ADDENDUM NO. 1 TO 18-0013-4

**FOR: JENNIFER ROSS SOCCER COMPLEX EXPANSION**

**JENNIFER ROSS SOCCER COMPLEX EXPANSION  
ITB #18-0013-4**

**ADDENDUM NO. 1**

FIG: SK-01

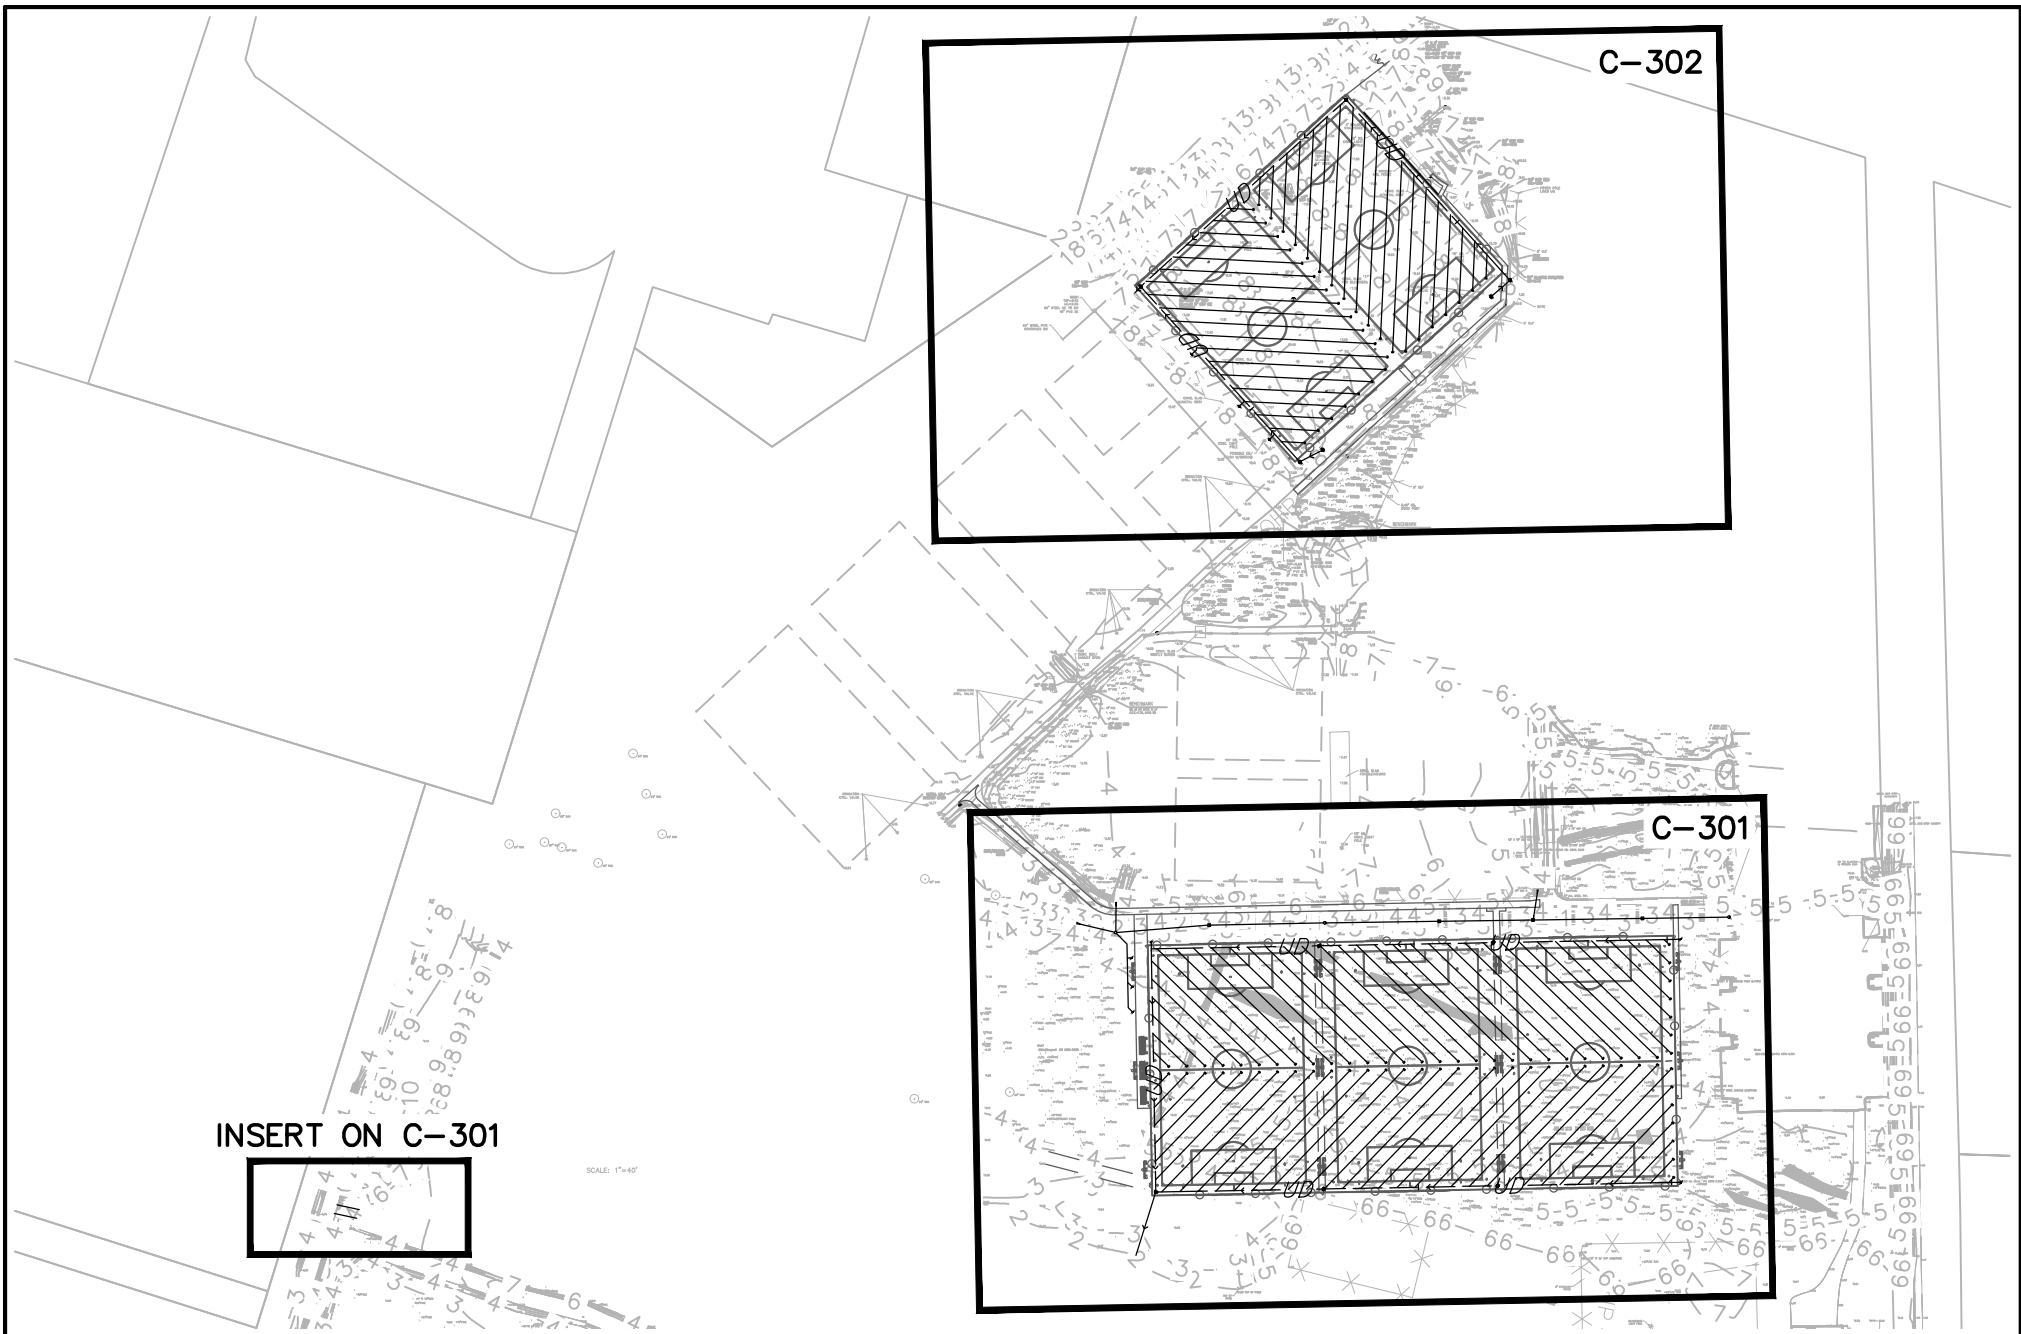
11. Question: Could you please identify the location of the pond outfall shown on Plan Sheet C-301 in the inset at the lower left hand corner of the page?

Answer: Please see attached sketch SK-01. In addition, the valve in the new pond outfall pipe has been removed from the project Work. Please reference the attached Figure A of C-301 for clarification.
